APPLICATION NO.	FILING DATE	FIRST NAMED INVENTOR	ATTORNEY DOCKET NO.	CONFIRMATION NO.
10/578,293	01/25/2007	Uwe Forster	2322.75089	6915
24978 7590 04/14/2009 GREER, BURNS & CRAIN 300 S WACKER DR 25TH FLOOR CHICAGO, IL 60606				
EXAMINER				
LOTFREDO, JUSTIN E				
ART UNIT		PAPER NUMBER		
3744				
MAIL DATE		DELIVERY MODE		
04/14/2009		PAPER

Office Action Summary

DETAILED ACTION

Burk – Figure. 1

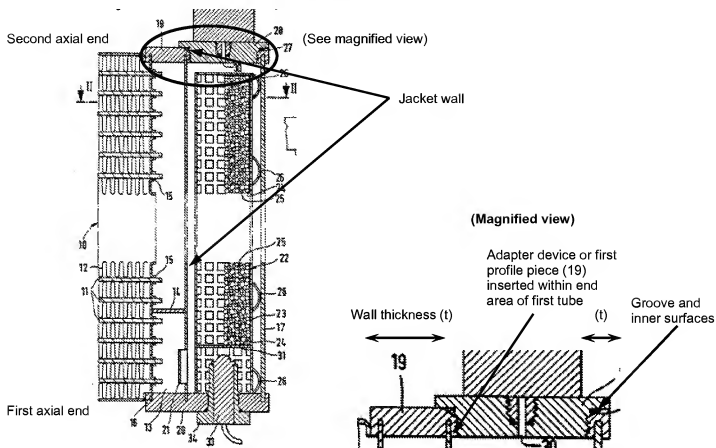
Consider claim 1. Burk discloses a collector/dryer unit for a condenser comprising: a collector (17), and a dryer (22) accommodated in exchangeable fashion therein, the collector having a jacket wall (see Figure 2 below) extending around its longitudinal axis formed by a first tube (see Figure 2 below), an opening provided above partition (14) (i.e. at least one inlet opening) and an opening (21) (i.e. at least one outlet opening), the outlet (21) in an end are facing a first axial end (see Figure 1 below) of collector (17), the collector (17) having an opening when screw cover (28) (i.e. a

detachable closure) is removed (i.e. removal opening at its second axial end) (see Figure 1 below), wherein on a side of the first tube facing away from the first end, common sealing plate (19) (i.e. an adapter device or a first profile piece) is provided on which the detachable closure (28) is held in a closed position (col. 2, L 18-col. 3, L 24; Figs. 1 & 2).

Consider claim 2. Burk discloses that the adapter device or a first profile piece (19) is inserted with an end area into an end of the first tube (see Figure 1 below).

Consider claims 4 and 5. Burk discloses that the adapter device or first profile piece (19) forms a segment of the jacket wall of the collector (17) (see Figure 1 below), the adapter device or first profile piece (19) having an opening designed as a threaded bore (i.e. extending around the longitudinal axis of collector (17); and having a tube-shaped structure), particularly around the second end of the jacket wall (col. 3, L 3-5; Figs. 1 & 2).

Consider claims 11 and 12. Burk discloses that the adapter device or the first profile piece having a space (i.e. a groove) between the detachable closure (28), the groove receiving a sealing ring (27) (i.e. a securing ring detachably situated in the groove); and by means of the securing ring (27) the detachable closure (28) is blocked in the direction facing away from the first end (col. 3, L 5-7; Fig. 1).

Consider claim 16. Burk discloses a sealing ring (27) (i.e. at least one O-ring) being held in a space (i.e. a groove of the closure) between the adapter device or the first profile piece (19), and the detachable closure (28); the at least one O-ring (27) achieving a sealing effect partly by contacting an inner surface of detachable closure (28) and the adapter device or the first profile piece (19) (col. 3, L 5-7; Fig. 1).

Consider claim 17. Burk discloses that in the direction of the longitudinal axis of collector (17), the adapter device or the first profile piece (19) is not as long as the first tube (Fig. 1).

De Keuster – Figure 1

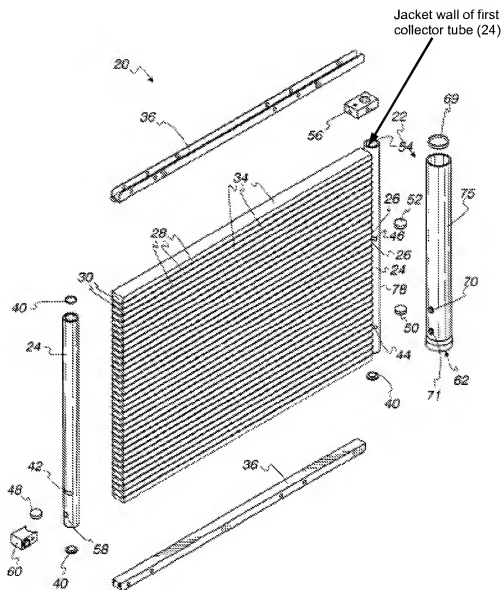
Consider claims 31 and 32. De Keuster et al. disclose that the condenser (20) has a tube/fin block having a plurality of tubes (28) essentially parallel in sections, and a plurality of fins (34) between the tubes (28); first ends of the tubes (28) and fins (34) being received by a rightmost header (24) (i.e. a first collector tube) and second ends of the tubes (28) and fins (34) being received by a leftmost header (24) (i.e. a second collector tube), and the collector (22) being parallel to first collector tube (24); the first collector tube having aligned openings (i.e. at least two openings) to receive the inlet (70) and outlet (71) (i.e. one opening is allocated to the inlet of the collector and the other opening is allocated to the outlet of the collector), thereby forming a segment of an overflow passage (col. 3, L 35-col.4, L 45; Figs. 1-4).

Consider claim 33. De Keuster et al. disclose that the first collector tube (24) has an exterior portion (78) above slot (44) (i.e. a shell shaped cover part) and an end plug (40) below slot (44) (i.e. a shell-shaped base part) connected thereto; the cover part and base part forming a jacket wall (see Figure 1 below) of the first collector tube (24) and tube slots (26) provided in both the cover part and base part (col. 3, L 35-53; col. 4, L 46-65; Figs. 1 & 2).

De Keuster – Figure 3

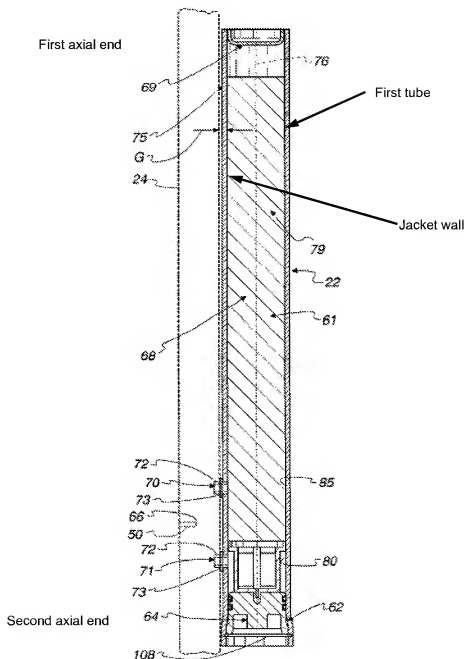
(22), the collector (22) having a jacket wall (see Figure 3 below) extending around its longitudinal axis formed by a first tube (see Figure 3 below), the collector having an inlet (70) and an outlet (71), the outlet (71) being in the end area facing a first axial end of collector (22), and a port (62) (i.e. a removal opening) at a second axial end facing away from the first axial end, and a plug (64) (i.e. a detachable closure) in the area of the second end, wherein in an embodiment compatible with both embodiments of Figures 3 and 4, on a side of the first tube facing away from the first end a separate piece or fitting (116) (i.e. an adapter device or a first profile piece) is provided on which the detachable closure (64) is held in a closed position (col. 2, L 25-30; col. 3, L 35-40; col. 4, L 8-45; col. 6, L 53-57; col. 7, L 4-7; Figs. 3-8).

Consider claims 21-24. De Keuster et al. disclose that the inlet (70) is in the end area facing the first axial end of collector (22); and that the inlet (70) and outlet (71) incorporate a short section of tube (72) with a peripheral rib (73) (i.e. rim holes protruding outwards / outwardly oriented projections having an annular outer contact surface); wherein at spaces for refrigerant passage are formed (i.e. at least a segment of an overflow passage is formed); wherein the protruding tubes (72) (i.e. stamped-out parts) are provided on the first tube (col. 4, L 16-45; Fig. 3).

Consider claim 29. De Keuster et al. disclose that a filter (66) is introduced and removed from the interior chamber (61) of the collector (22) appropriately (col. 4, L 15-25; Figs. 3 & 4. Note that Fig. 3 is mislabeled in that reference numeral (66) should be directed to the filter within the collector (22) as in Fig. 4).

Consider claim 34. De Keuster et al. disclose that the inlet (70) and outlet (71) incorporate a short section of tube (72) with a peripheral rib (73) to form nipples (i.e. rim holes) which can be received in aligned openings (i.e. rim holes protruding inward) of the first collector tube (24) (col. 4, L 15-45; Figs. 3).

Consider claim 41. De Keuster et al. disclose that the collector (22) and first collector tube (24) are help spaced apart by a gap (G) (i.e. a slot) (col. 4, L 58-62; Figs. 3 & 4).
